# Florida Greenbook

## Sub-committee Meeting

Chapter 4 – Roadside Design

**December 10, 2025**  
2:00 PM – 4:00 PM

Figure 4-9. Location of Guardrail

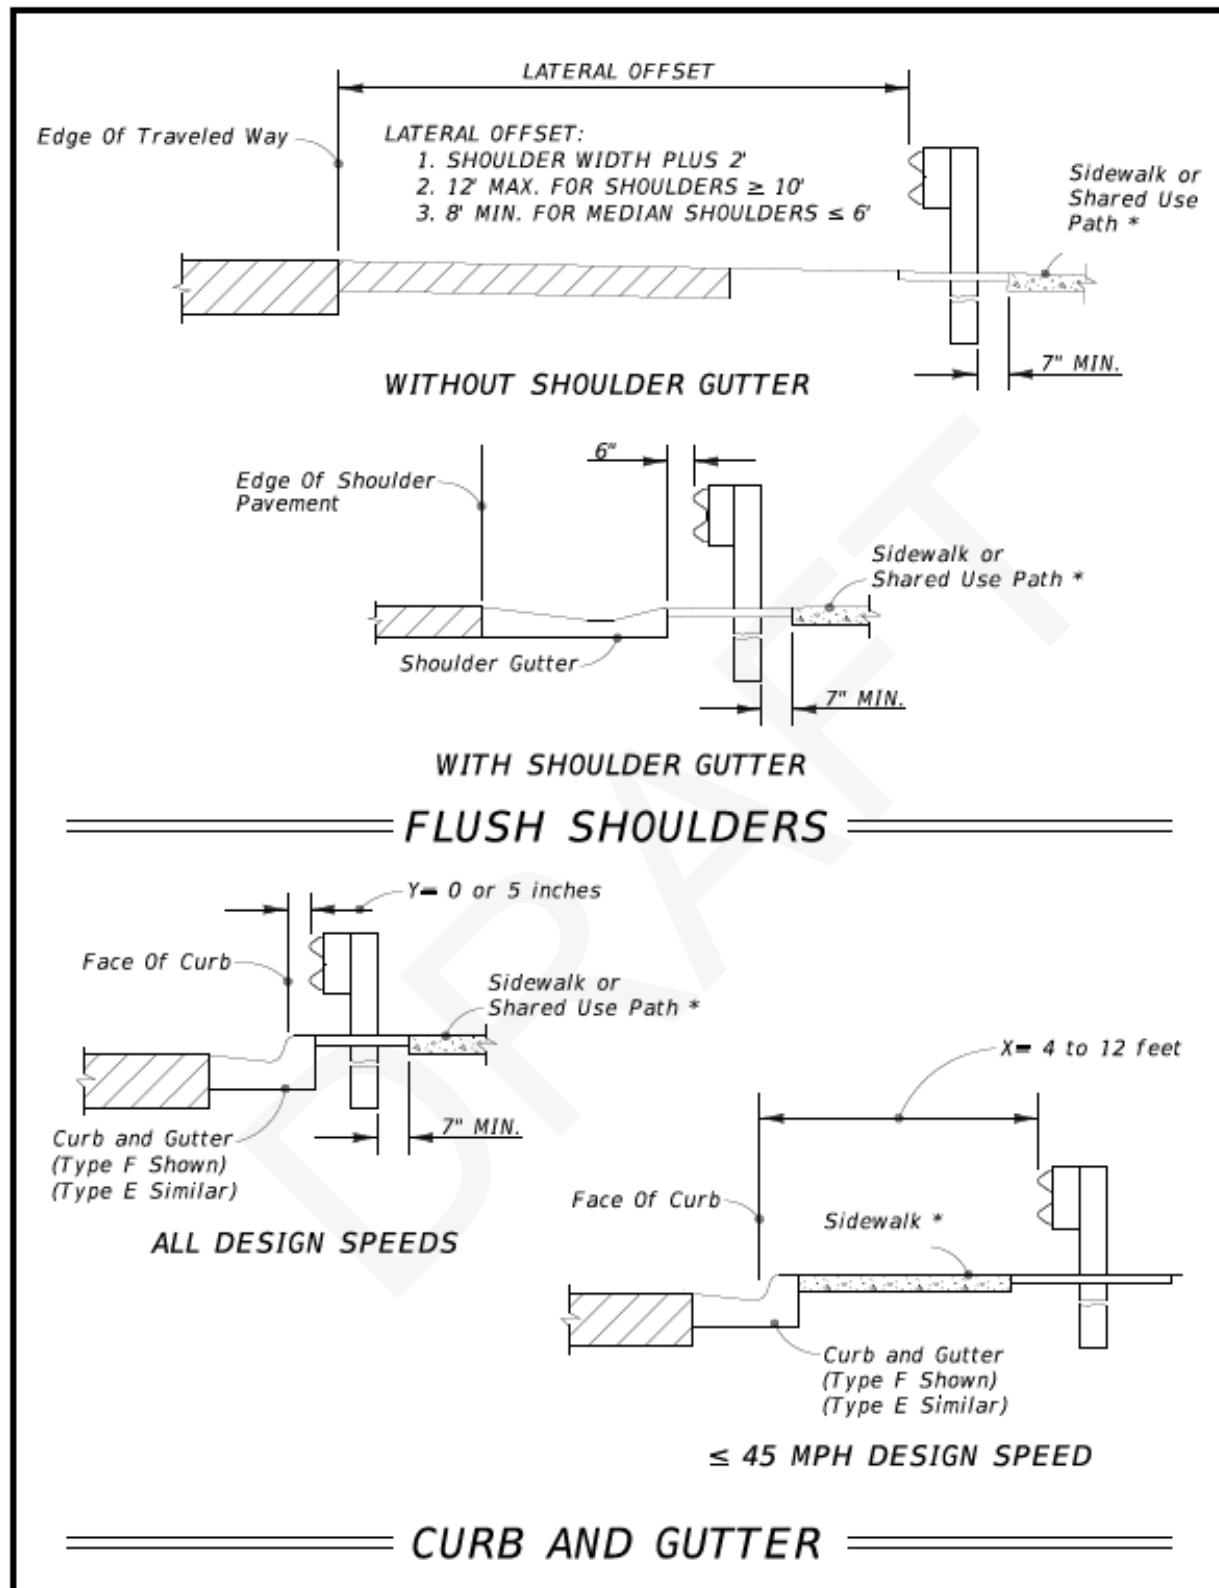
**Committee** – Note for the following figures (and other figures in this chapter): we will work with Daniel Eichler to ensure all the drawings are from the pending 2026 FDM and have any modifications necessary to be applicable to the Greenbook.

**Figure 4-11. Approach Terminal Usage When End of Guardrail Is Within Clear Zone of Approach Near (Top) and Far (Bottom) Lane (Two-Lane, Two-Way Road Shown)**

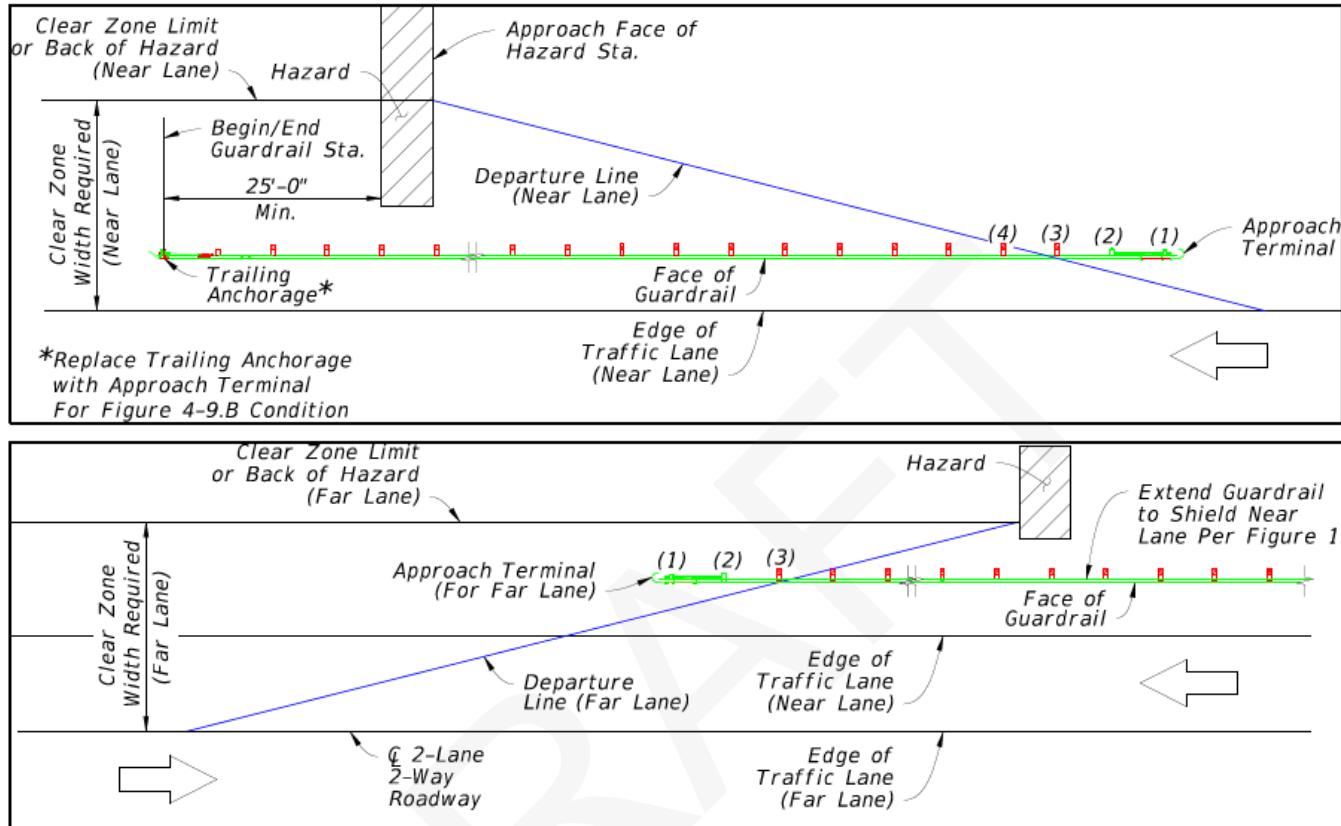
**Committee** – Figure 4-11 currently refers to Figure 4-9 B and will be corrected when we begin updating all the figures.
